Highgate School – Richard’s Music Centre – Carbon Management Planning Responses

Date
8th August 2025

On 10th April 2024, Haringey Council provided a Carbon Management Response (REF: HGY/2023/0315) which confirmed objection to the application. Within this, the Council stated that “*Carbon Management cannot currently support this application. Some clarifications must be provided with regard to the Energy Strategy, Overheating Strategy and Whole-life carbon Assessment. This should be addressed prior to the determination of the application.*” A meeting was held 10th March 2025 between AECOM, Highgate School, Haringey’s Carbon Management team and the Case Officer to discuss the response and comments by the Carbon Management team. AECOM has liaised with the design team in order to respond to the concerns raised. The response tracker below contains the concerns and queries raised by Haringey council and the design team responses to these.

Figure 1 Part L 2021 energy demand breakdown for RMC.

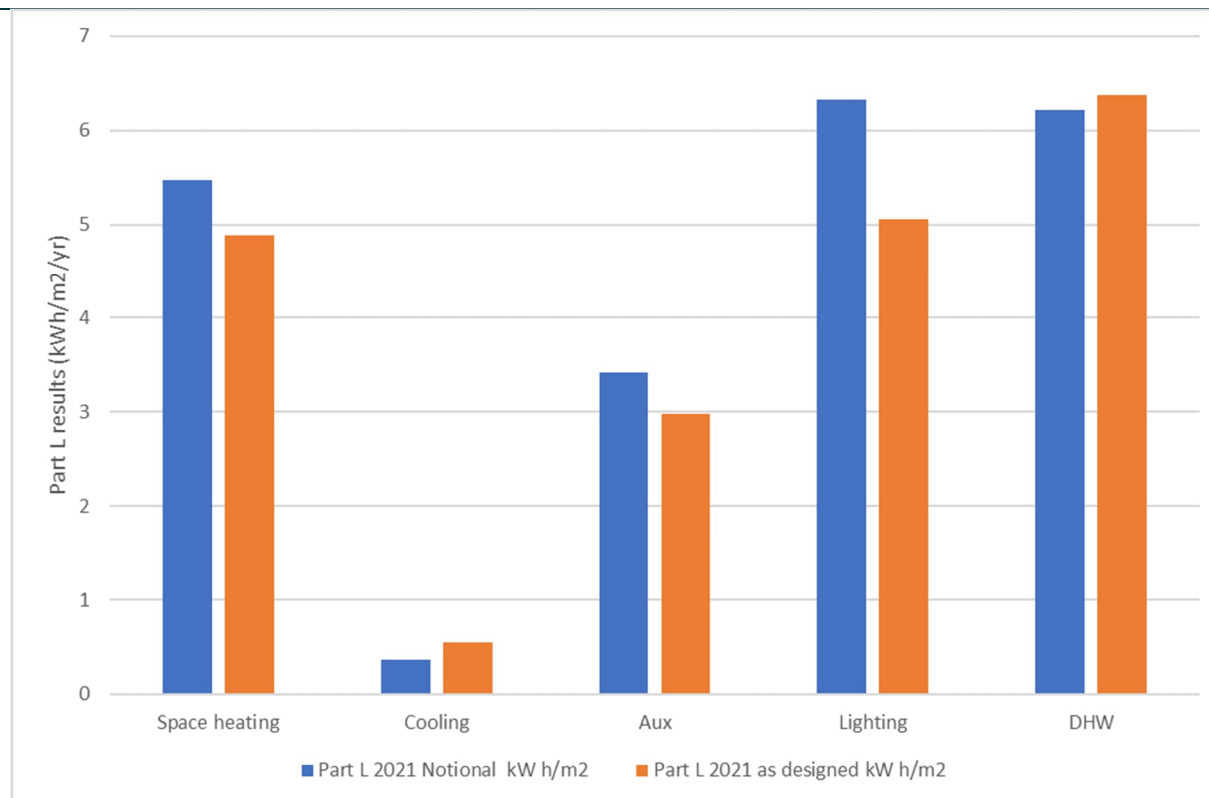
3. Also, the cooling demand is higher than the notional cooling demand and the overheating assessment is required to properly following the London Plan's cooling hierarchy incorporating all passive measures to reduce the overheating risk of the building and minimise the cooling demand before introducing any mechanical form of cooling.	As outlined in section 4 of the energy statement, the cooling hierarchy has been followed to minimise cooling demand as far as possible and reduce overheating. Mechanical cooling is only proposed to areas which would otherwise overheat despite the inclusion of passive measures. In some areas, for example the theatre, openable windows have been avoided as this would likely not meet the functional requirements of the space. Windows are also not included in changing rooms (which are below ground). Openable windows are included where other constraints allow. Some spaces and the theatre are below ground, in part to help in responding to neighbours' concerns about building height. This limits the potential for natural ventilation in these spaces. Despite these limitations, passive measures have been included in the building design where possible to reduce overheating risk and mechanical cooling demand. These include: • Inclusion of efficient lighting to reduce heat gains (as outlined above, proposed lighting efficiency has since been further improved). • Use of high performance solar control glazing to reduce summer heat gains. • The incorporation of horizontal shading fins to the southern elevation. • Building insulation to reduce conductive heat gains. • Exposed soffits to provide some limited thermal mass benefits. • Natural ventilation in some spaces where constraints and predicted thermal comfort levels allow. Cross-ventilation and high-level clerestory ventilation louvres are included in addition to large openable areas. In addition to the above it is noted that the cooling energy demand is a very small compared to all other regulated energy uses. This is in part due to the cooling hierarchy being followed and few rooms having mechanical cooling included in the design.

Figure 2 Drama Classroom Ventilation Strategy.

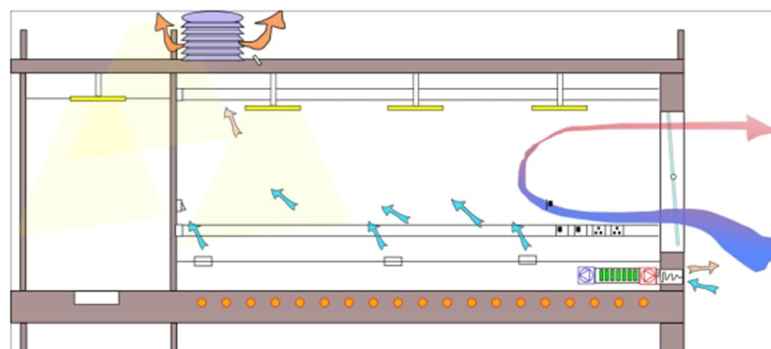
6.	Please identify on a plan where the MVHR units will be located within the building. The units should be less than 2m away from external walls. This detail can also be conditioned.	The MVHR units are located within the floor void and next to the external facade to allow of local fresh air supply to the classrooms. The images below show typical cross sections of rooms which incorporate MVHR.

Figure 3 Proposed borehole location under the building (shown in red shading)

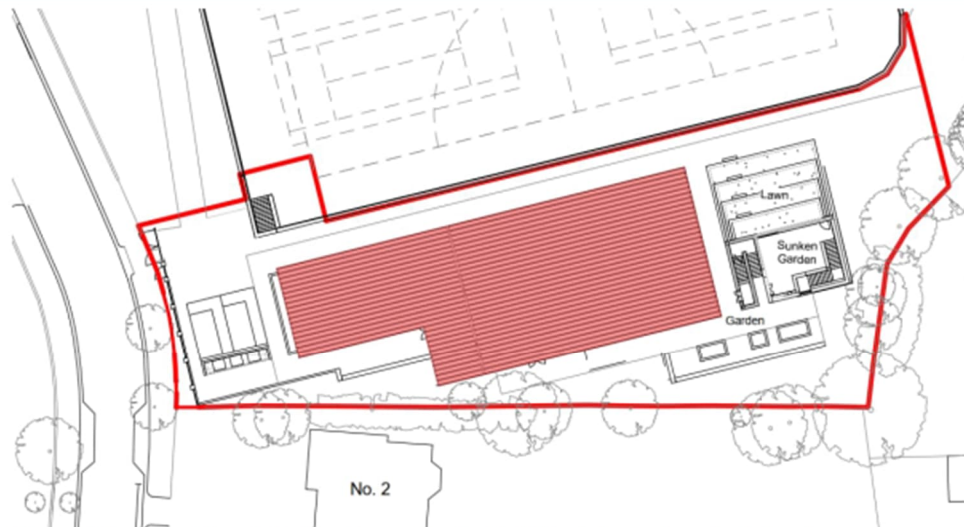
15.	What is the proposed indicative capacity of the GSHP and the thermal storage? Please ensure the location of GSHP is also annotated on plans.	The GSHP system will provide 150 kW_p heating and 40 kW_p cooling. The proposed thermal storage tank size for heating purposes is 2,500 litres, and for cooling purposes is 750 litres. The locations of the GSHP boreholes and plant room are detailed in Figure 3 and 4 in the RMC Energy Statement which are reproduced below:

The full cooling and heating load will be provided by geothermal heat pumps located at basement level plant room. This will consist of a closed loop geothermal system using a geothermal borefield located beneath the building. A ground source heat pump specialist sub-contractor shall be employed for the detailed design, supply, delivery, installation, testing, commissioning and setting to work of the GSHP system.

Figure 5 Submitted “Be Seen” webform for RMC

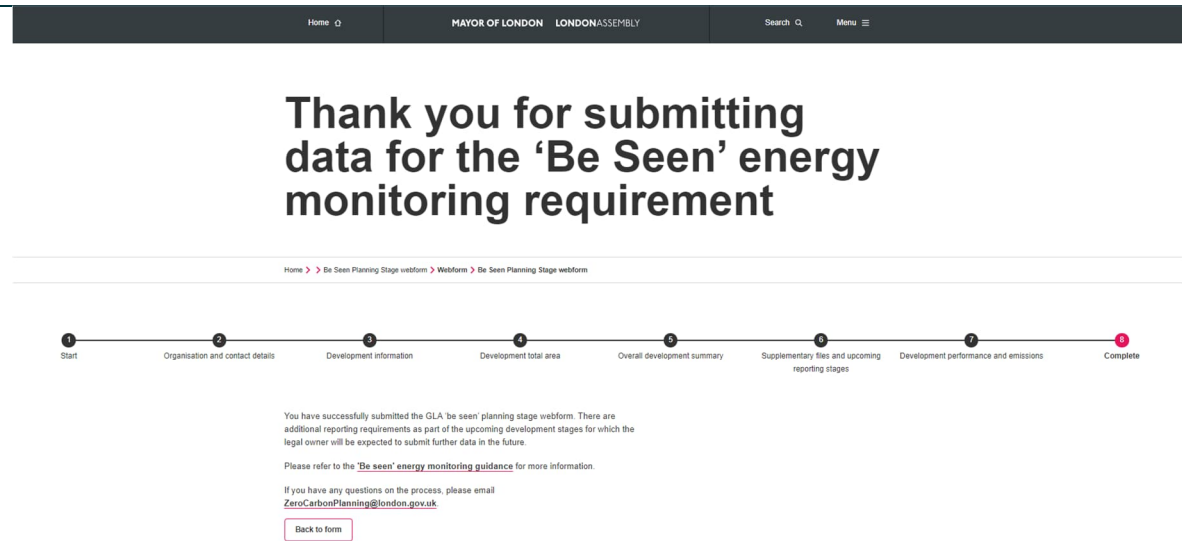
19.	Demonstrate that the planning stage energy performance data has been submitted to the GLA webform for this development: (https://www.london.gov.uk/what-we-	The screenshot , taken at the time of submission confirms the planning stage energy performance data has been submitted to the GLA via the webform.

Figure 6 Energy demand breakdown for RMC

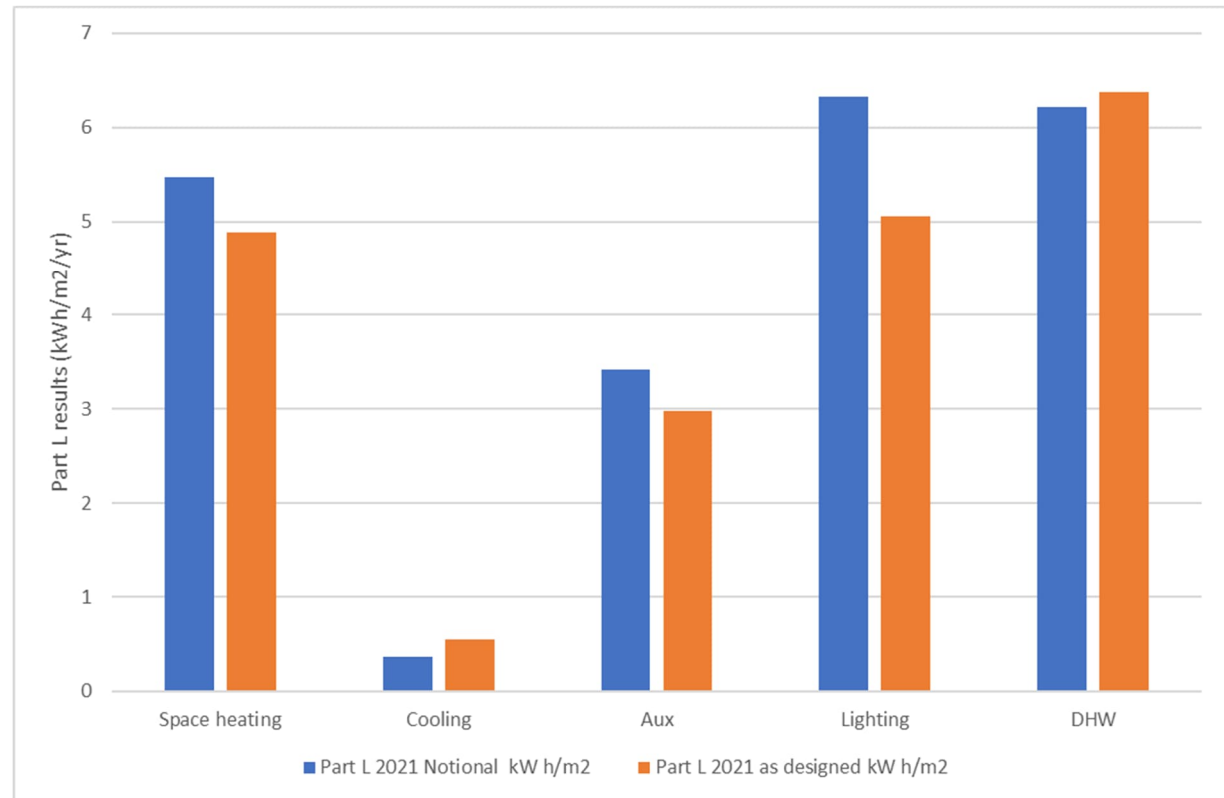
21. The cooling demand is 1.5x times higher than the notional cooling demand. Please follow the cooling hierarchy in order and step by step, and first implement all passive measures to reduce the overheating risk and the cooling demand before introducing any mechanical form of cooling.	As outlined in section 4 of the energy statement, the cooling hierarchy has been followed to minimise cooling demand as far as possible and reduce overheating. Mechanical cooling is only proposed to areas which would otherwise overheat despite the inclusion of passive measures. In some areas, for example the theatre, openable windows have been avoided as this would likely not meet the functional requirements of the space. Windows are also not included in changing rooms (which are below ground). Openable windows are included where other constraints allow. Some spaces and the theatre are below ground, in part to help in responding to neighbours' concerns about building height. This limits the potential for natural ventilation in these spaces. Despite these limitations, passive measures have been included in the building design where possible to reduce overheating risk and mechanical cooling demand. These include:

- Inclusion of efficient lighting to reduce heat gains (as outlined above, proposed lighting efficiency has since been further improved).
- Use of high performance solar control glazing to reduce summer heat gains.
- The incorporation of horizontal shading fins to the southern elevation.
- Building insulation to reduce conductive heat gains.
- Exposed soffits to provide some limited thermal mass benefits.
- Natural ventilation in some spaces where constraints and predicted thermal comfort levels allow. Cross-ventilation and high-level clerestory ventilation louvres are included in addition to large openable areas.

In addition to the above it is noted that the cooling energy demand is a very small compared to all other regulated energy uses. This is in part due to the cooling hierarchy being followed and few rooms having mechanical cooling included in the design.

Figure 7: Overall Building Ventilation Strategy

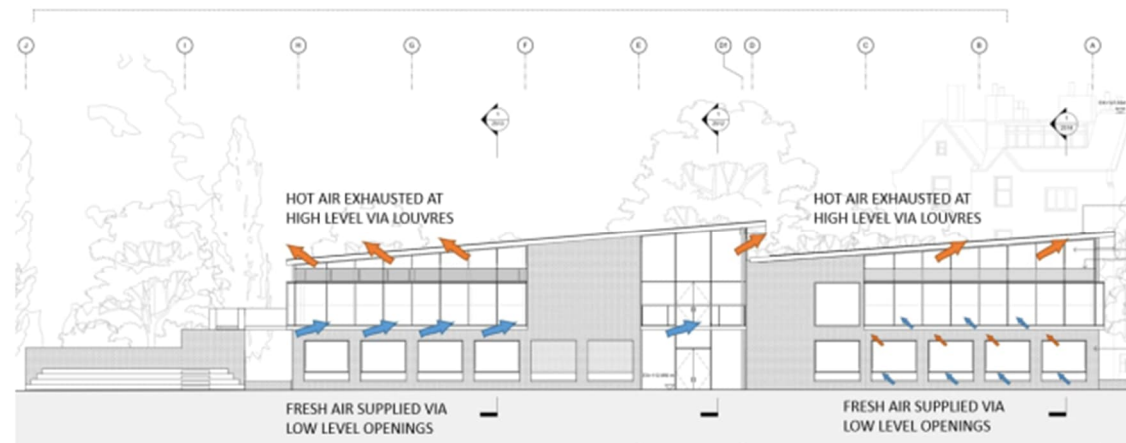
22. It is currently unclear which rooms will be naturally ventilated with MVHR, and which rooms will have active cooling. Submit a plan specifying the ventilation strategy and overheating risk mitigation strategy, as requested at pre-application stage.

Mechanical cooling is only utilised in the studio theatre which will be connected to the centralised heat pump system. The building services plant is centralised in the following primary locations: main plant room, basement, and Studio theatre AHU plant room.

Above ground rooms on the perimeter will be naturally ventilated in the summer and mechanically ventilated by localised low power heat recovery units in the winter. The basement will be mechanically ventilated. The studio theatre and associated switch room, control room and AV dimmer room will be the only mechanically cooled areas.

Appendix 2 – Roof plan including PV thin film

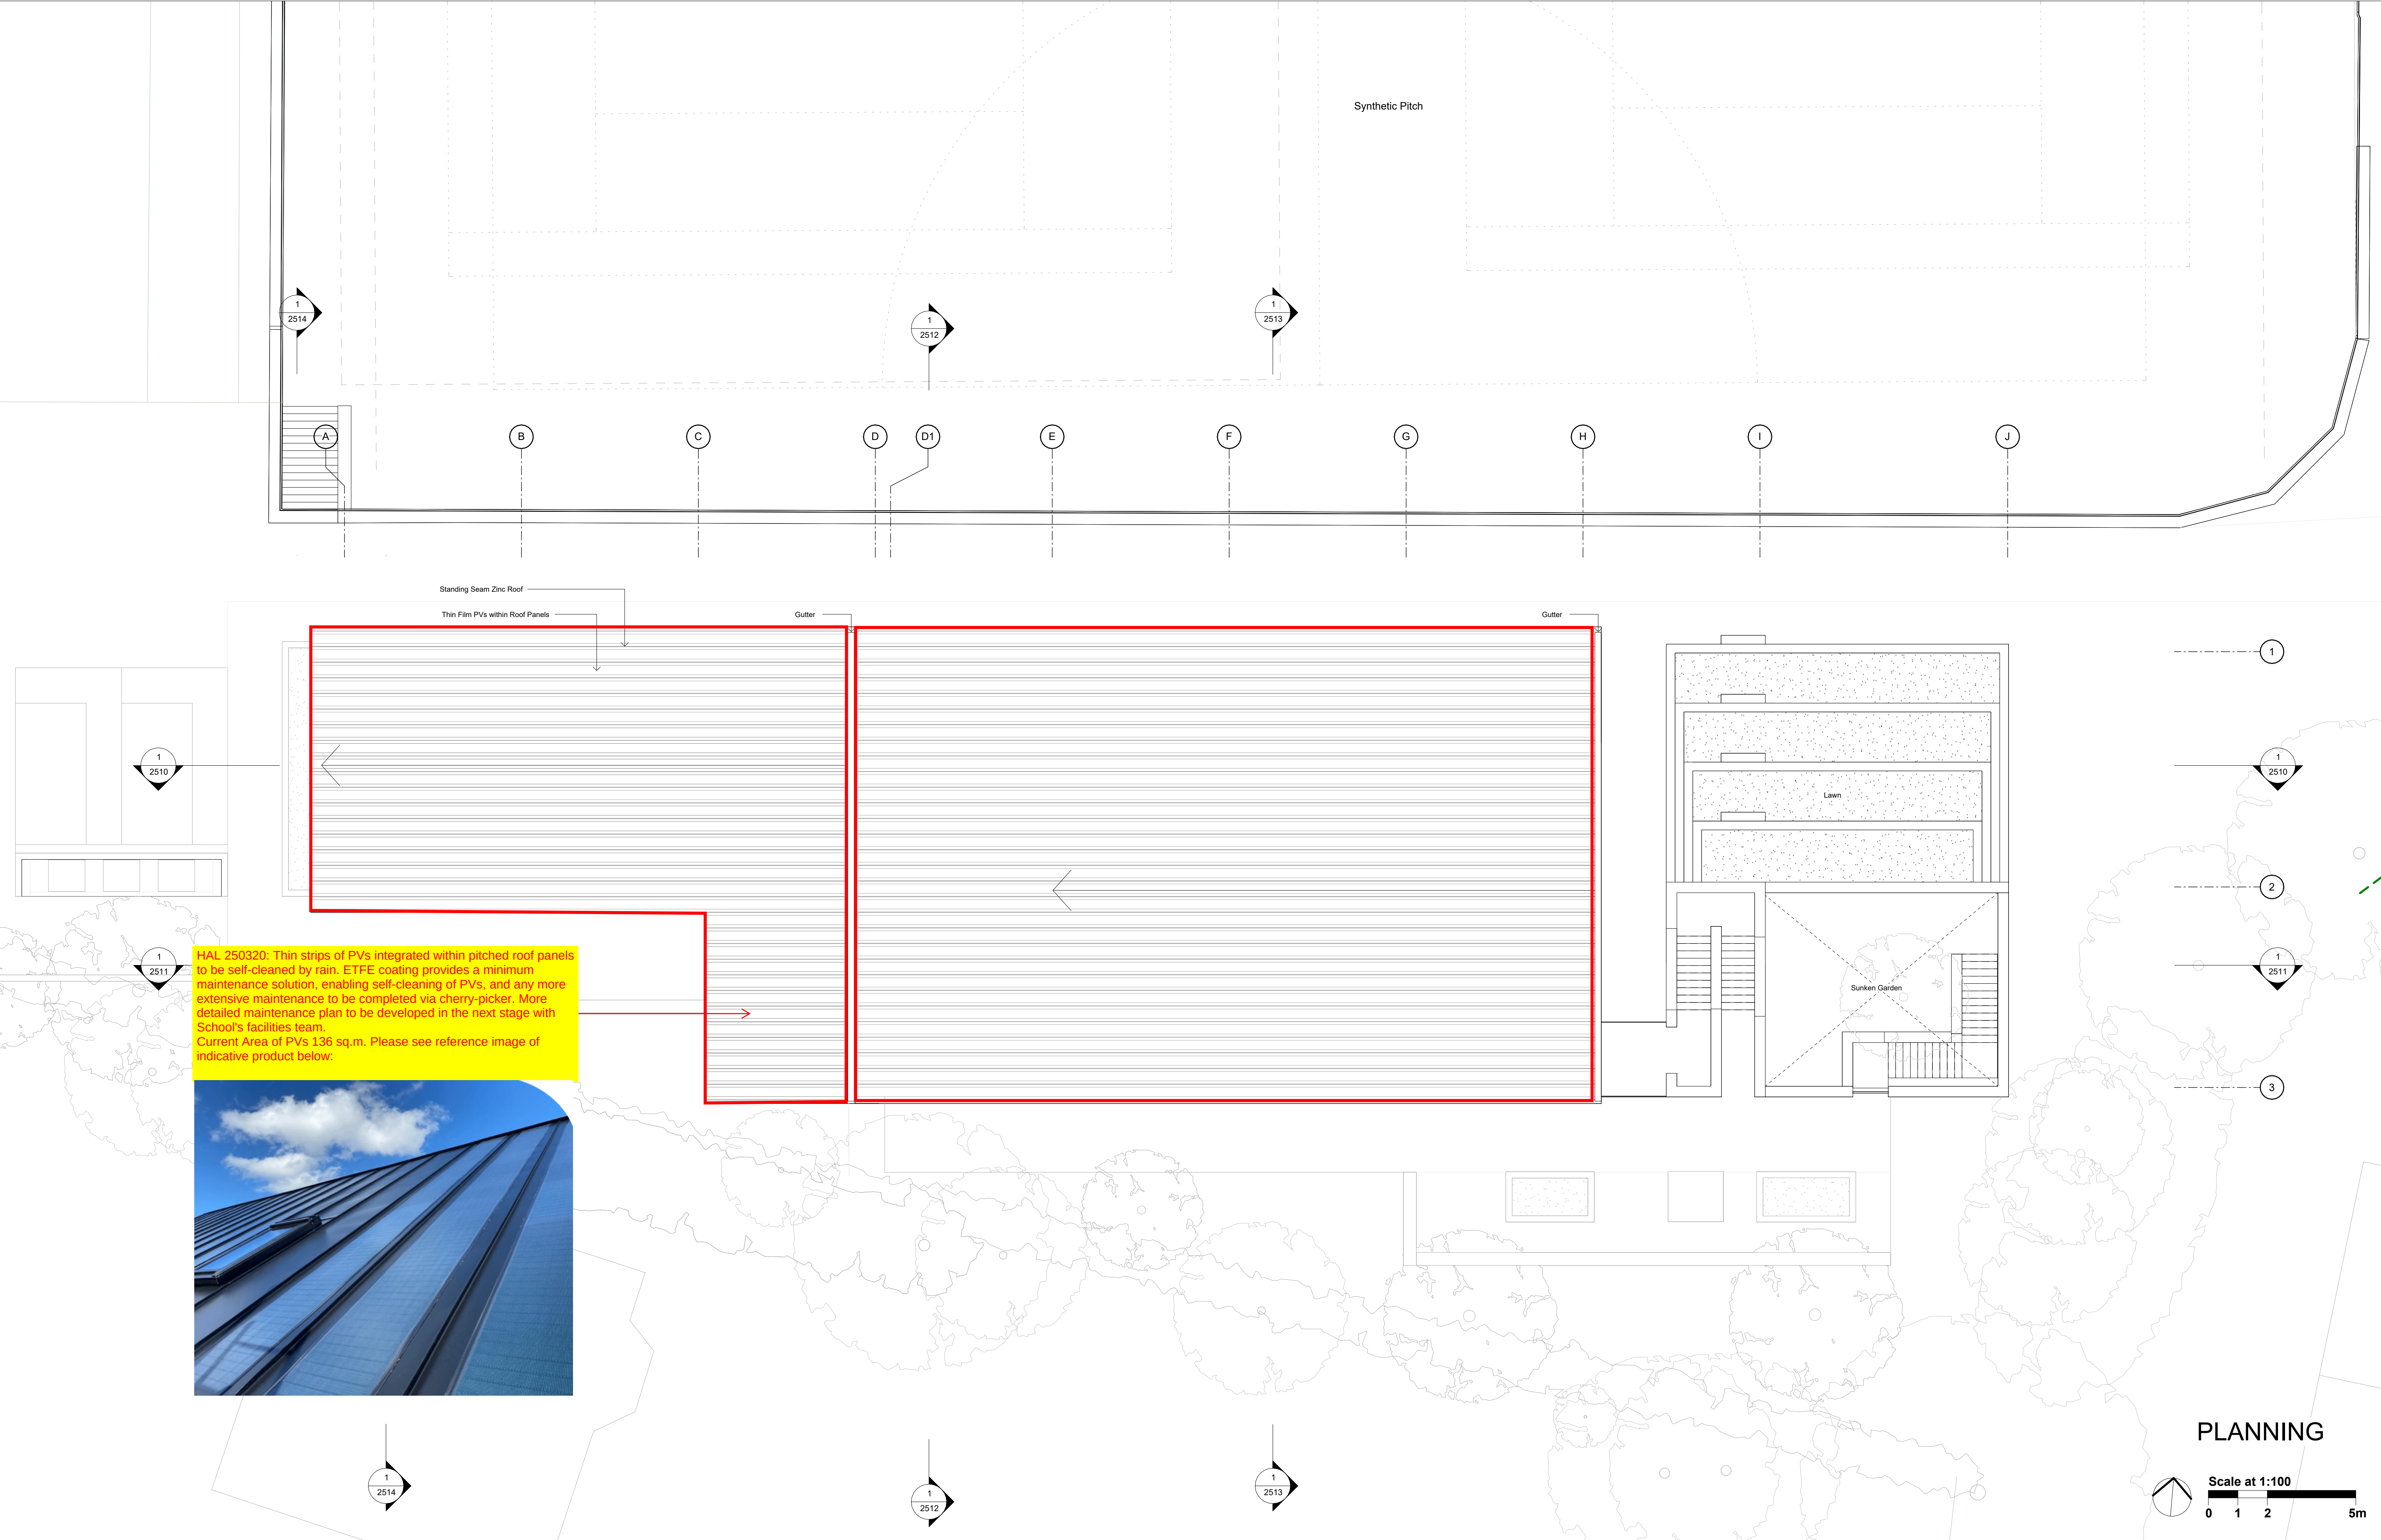
16.	Detailed plan, edges, access points for maintenance..... etc. for solar panels	Detailed layout of solar PV panels will be undertaken during detailed design. Figure 2 in the energy statement shows the proposed PV film location on the roof of the building. A higher resolution plan is included in Appendix. 2 The proposed active PV area is 136 m². Maintenance requirements are expected to be minimal as the cells incorporate an ETFE coating for water, UV and chemical resistance. The panels are also designed to be self-cleaning through the use of the roof slope and hydrophobic and oleophobic properties of the ETFE coating. This allows rainwater to clean the panels. When access for more extensive maintenance is required, a cherry picker will be used. The school's facilities team will work in coordination with Hopkins to produce a more detailed maintenance plan during the detailed design stages.
